### ProFiller 1100 More Than a New Name! Changes shown below are versus the ProFill 100

- All Parts Automatic Dishwasher Safe
- Conversion Kit Eliminated & Orienter Base Common for Sizes 00-4
  - 25% Smaller & Lighter Design\*
- Ten frequent customer requests implemented

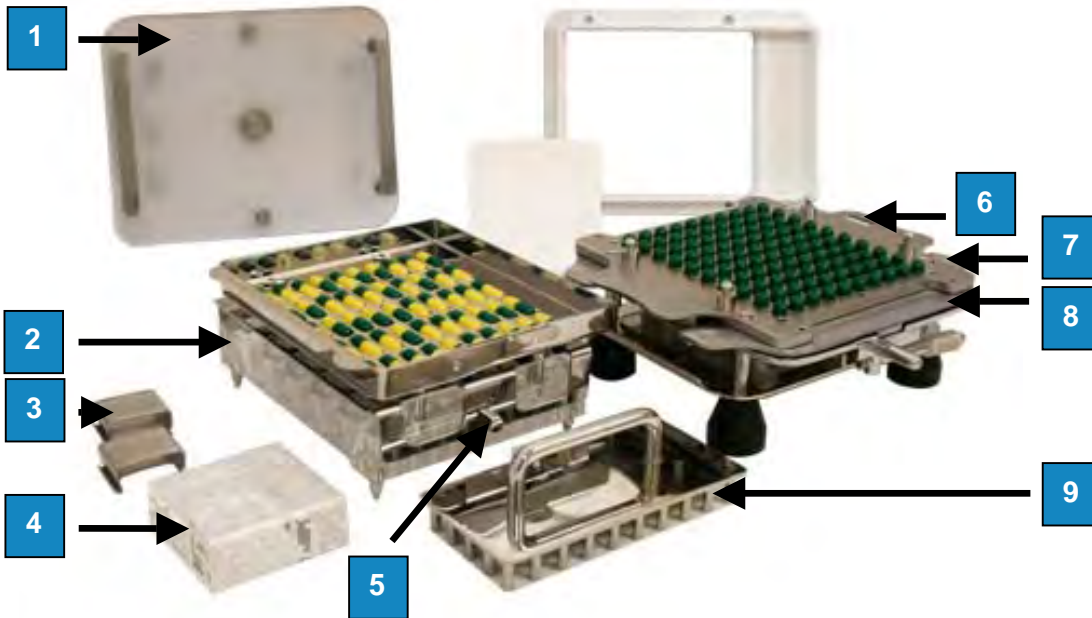
<b>1</b>	<ul style="list-style-type: none"> <li>• Locking Plate has domes to eliminate cap denting when filling coarse powders.</li> <li>• Stainless steel screws replace plastic screws to eliminate breakage.</li> </ul>
<b>2</b>	Orienter Base common for size 00-4, eliminating the need for a Conversion Kit.
<b>3</b>	Powder Tray Clamps Included.
<b>4</b>	Capsule Locker included for easy capsule locking & consistent capsule length.
<b>5</b>	Orienter change part connected with 2 horizontal screws instead of 4 vertical screws.
<b>6</b>	Locked capsule checker included.
<b>7</b>	Stainless Steel Caps Tray is automatic dishwasher safe.
<b>8</b>	25% lighter weight for customers who tap the filler during filling.
<b>9</b>	Tamper Pin diameter optimized. New range is 00, 0-1, 2-3 and 4.

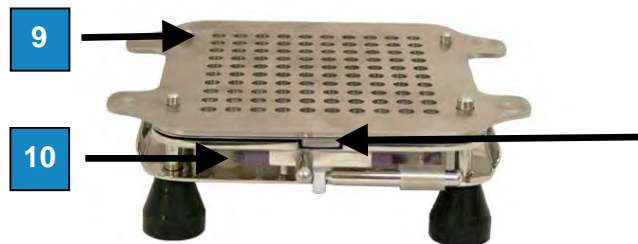
<b>9</b>	Corner holes inside Powder Tray area removed from Top Sheet "c".
<b>10</b>	New Spacer Plate design prevents feet from falling out after repeated automatic dishwasher cleaning.

<b>11</b>	New Cam & "b" sheet design to prevent powder entry in cam area.
